TSB # 14-2017

TO: All Bourgault Dealers  
ATTN: Service Manager, Parts Manager, Sales Manager  
SUBJECT: Wing-lift Circuit - Orifice Relocation

## INFORMATION BULLETIN:

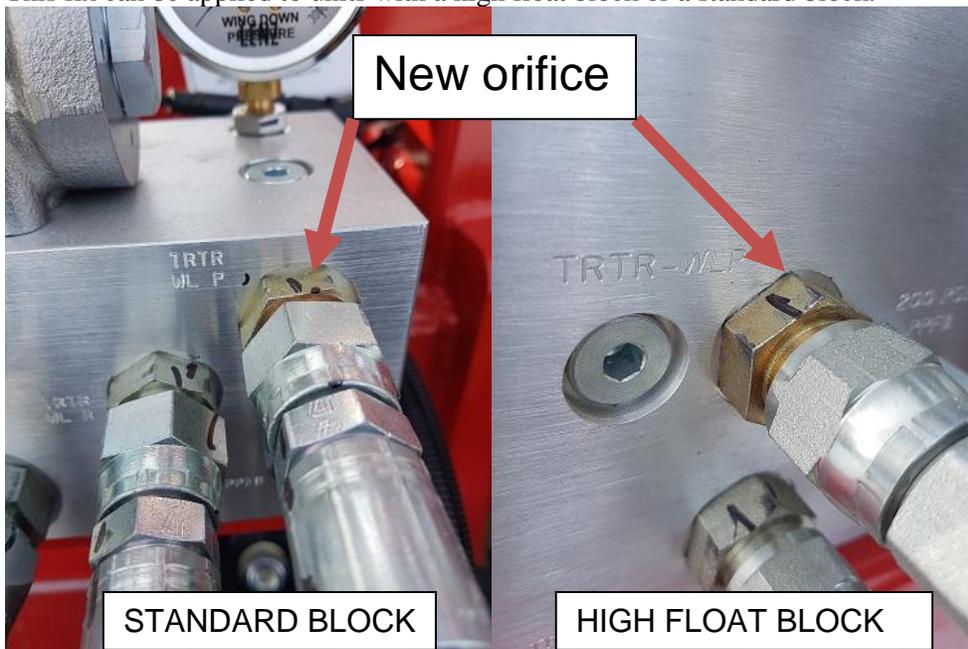
- Remove the orifice located on the pressure or supply hydraulic hose

Remove and discard this orifice

- Install the new orifice (3371-48) into the TRTR WLP port stamped on the hydraulic block.
- This fix can be applied to units with a high float block or a standard block.
